VIRGINIA
DIVISION OF HISTORIC LANDMARKS
HISTORIC DISTRICT/BRIEF
SURVEY FORM

File no. 76-390-016

31 August 1993

Re: Proposed Manassas Bypass
Prince William County
FHWA-VA-EIS-79-03-DS
VDOT Project No. 6234-076-F11, PE101
VDHR File No. 90-0911-F

Figure 35: Proposed Manassas Bypass, Southern Section Showing Lake Jackson and Lake Jackson House (76-72)

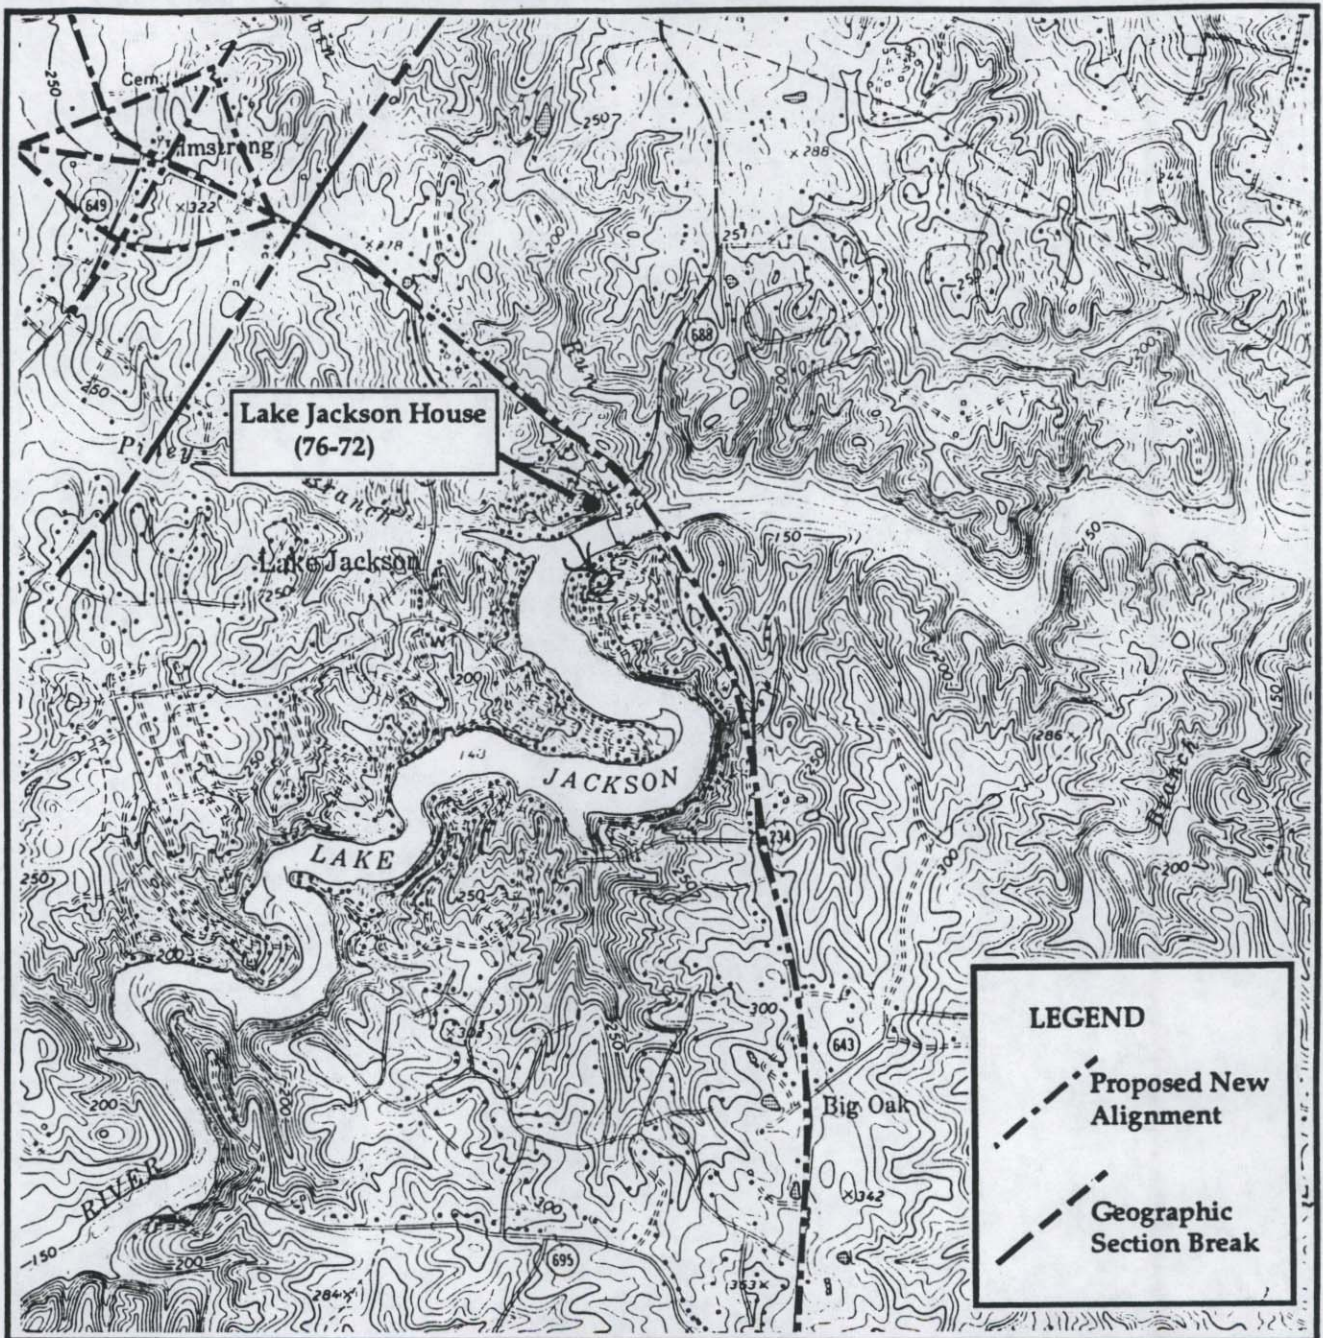
We concur with your consultant's determination that the undertaking will have an adverse effect on the following historic properties: Bloom Hill (76-149), Bradley (76-70), the Lake Jackson Historic District (76-390), and the Manassas Battlefield. Resources affected on the Manassas Battlefield include The Manassas National Battlefield Park (76-271), Pageland I (76-138), and Pageland II (76-137).

We appreciate the efforts made at this stage of environmental analysis to reduce the adverse effects on Bradley, Bloom Hill, Pageland I, and Pageland II. We encourage your agency and the FHWA, however, to reconsider the following project alternatives which, in our opinion, would eliminate the adverse effects of the undertaking on historic properties. We urge that the interchanges with Routes 649 and 673 be eliminated or relocated

elsewhere. Such an alternative would eliminate the adverse effect at Bradley and would reduce the adverse effect at Bloom Hill below the level advocated in the DSEIS. For the Manassas Battlefield area, we recommend that Alternative 3 be reconsidered which would terminate the project at I-66 and would avoid most of the resources on the battlefield (including Pageland I, Pageland II, and the Manassas National Battlefield Park). Reconsideration of Alternative 3 should also include comparison to a modified Selected Alternative which would include closure of existing Route 234 through the park to partially mitigate the effect of the undertaking on that historic property.
